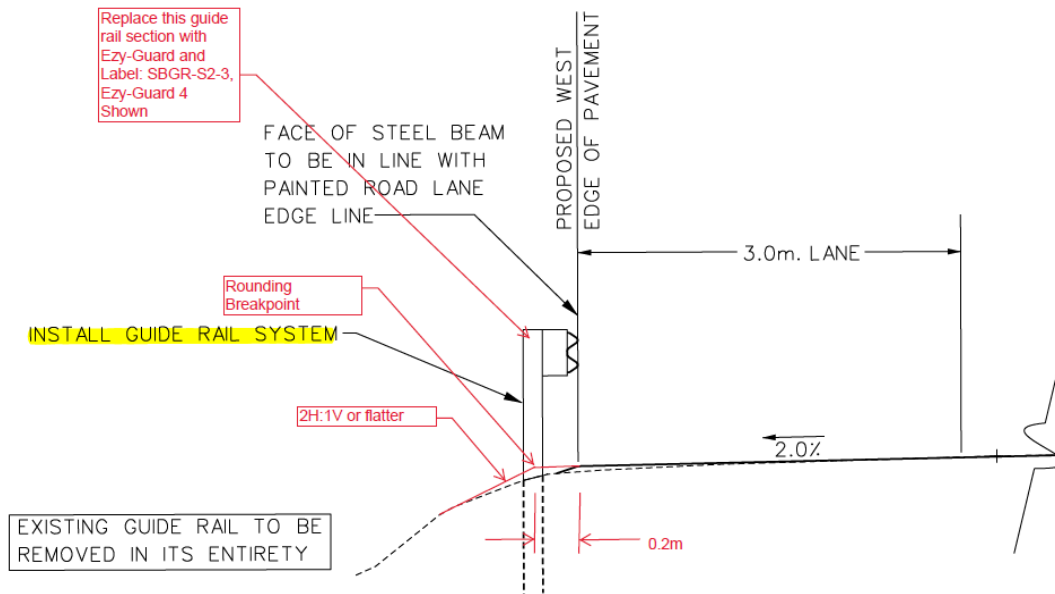
Sheet 4 of the contract drawing set includes a typical "Guide Rail Detail" (cross section taken at Sta. 1+280). This detail shows the guide rail post installed on a slope, which is not acceptable according to current standards. In addition, the proposed surface drops off abruptly in front of the guide rail. Generally, the surface in front of the guide rail post should be a maximum of 10%.

To accommodate the field conditions, it is recommended that a blockless SBGR system be used to accommodate the narrow roadway platform resulting from the proposed cross section. The blockless SBGR systems are 200 mm in width. The post for the blockless system must remain on the traffic side of the rounding breakpoint. Currently, there are two blockless SBGR systems accepted for use by MTO: Ezy-Guard 4 and ACP Sentry. Both systems meet AASHTO MASH Test Level 3. We will reference the current MTO Standard Special Provision (SSP) 721S09 to specify the blockless SBGR systems and this will be noted on the drawing.

It is recommended that the "Guide Rail Detail" on Sheet 4 be updated to reflect the blockless SBGR system. In addition, it is recommended that the proposed cross sections be updated to provide a minimum 0.2 m extension of the roadway platform with granular A shouldering and 2H:1V slope to tie into existing slope. SRE will include an updated version of the typical section below as part of our drawing set per the markups noted below.
